TALLYN'S REACH

TREE PROTECTION PLAN

P.A. 11, 12, 13
AND 34 - FILING 15

TALLYN'S REACH FLG 15 TPP PA 11,12,13,34 2005-0007

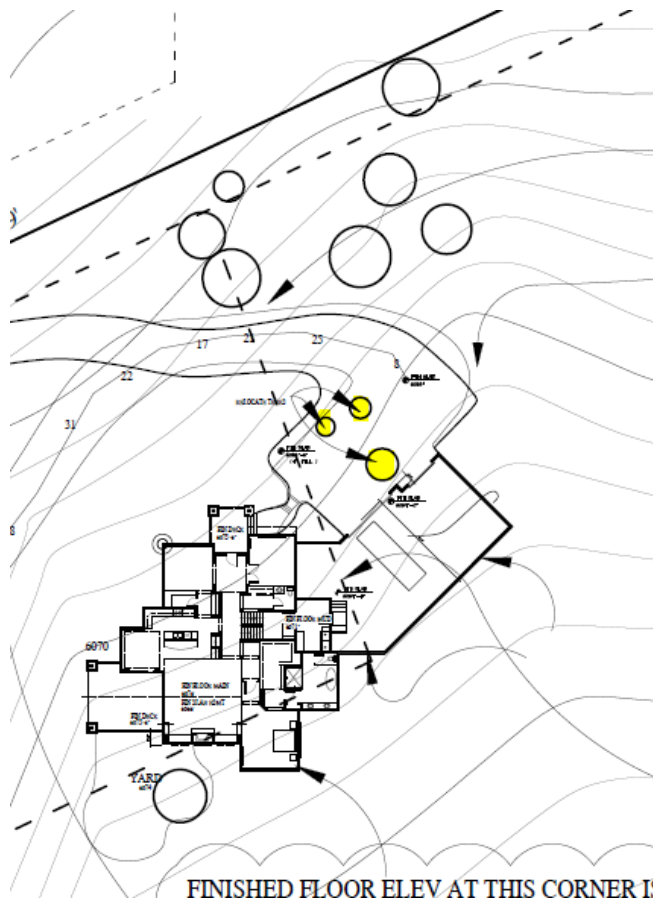
Those are the trees in question. Thanks again for looking into this!

Please verify that these are the trees that you are referring to. If so, I will send another email with permission to move them.
Jacque

Since those trees were not part of the original Tree Protection Plan, you will not be required to mitigate them or to change/amend the Landscape Plan to accommodate their relocation. You are allowed to relocate them to another area of your property with no issues related to the Black Forest Ordinance. Likely the trees were too small at the time the initial inventory was conducted.

Just to reiterate something we talked about on the phone earlier...aftercare is extremely important when you move a tree. No sense moving it, if you don't have a good watering plan for the tree. You should make sure that the trees are staked (take the staking material off approximately one year after moving the trees), and make sure they are well watered. You should water approximately 10 gals. Per diameter inch three days per week. For example, if the tree is 8" in diameter, then you should be prepared to water it 80 gals three days per week. This should be done in the first year, particularly in the growing season. It would really only need to be done in the winter a couple times a month if there wasn't good snow cover.

It usually takes about one year for every diameter inch of a transplanted tree to recover. So an 8" diameter tree will take about 8 years to fully recover from transplanting and begin really growing again.
